SERVICE BULLETIN

No. 324

Piper Aircraft Corporation

Subject: Vacuum Pump Adapter Drive Assembly

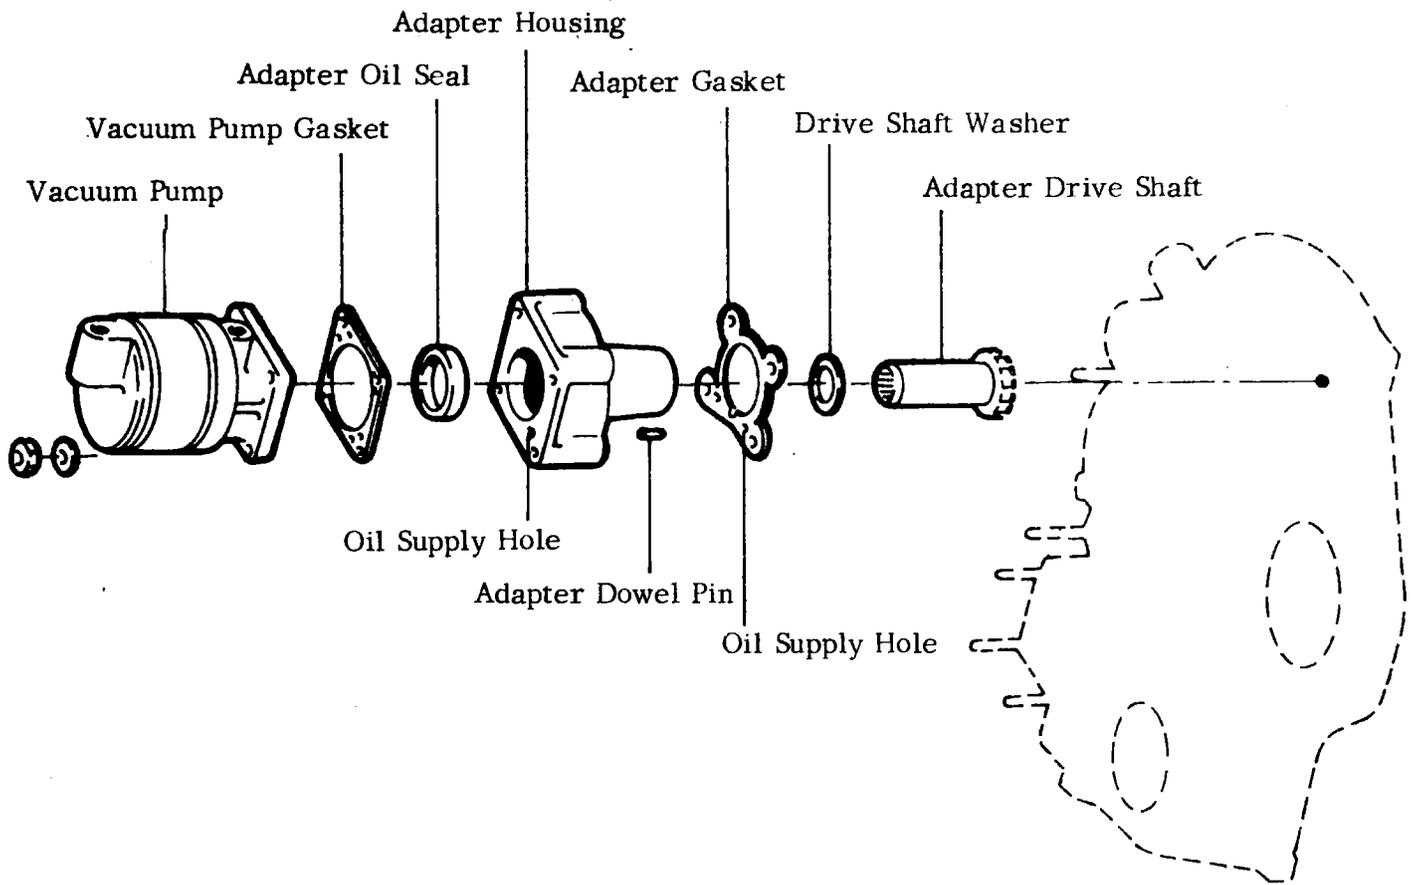
To provide instructions for an inspection of the vacuum pump adapter drive assembly (reference attached sketch for an illustration of the area to be inspected).

- I. Remove vacuum pump and vacuum pump adapter assembly from engine.
- II. Remove drive shaft from adapter housing and inspect the shaft for any sign of aluminum pick up on shaft at either end of shaft where it contacts adapter bearing bore.
- III. Inspect the adapter housing for the following:
 - a. Any evidence of inadequate lubrication resulting from foreign chips in oil supply hole.
 - b. Omission of oil supply hole.
 - c. Improper location of dowel.
 - d. Improper indexing of drive adapter assembly to accessory pad.
- IV. Inspect gasket, Lycoming part number 61183, for omission of oil transfer hole.

IF ANY DISCREPANCIES ARE FOUND, DO NOT ATTEMPT TO REPAIR. Contact your local Lycoming Regional Representative or Lycoming Service Department for further instructions.

- V. If the above referenced inspection procedure discloses no discrepancies, clean and lubricate (with SAE 50 oil) all parts that were inspected and reinstall on engine; torque all nuts to 50 to 70 inch pounds.
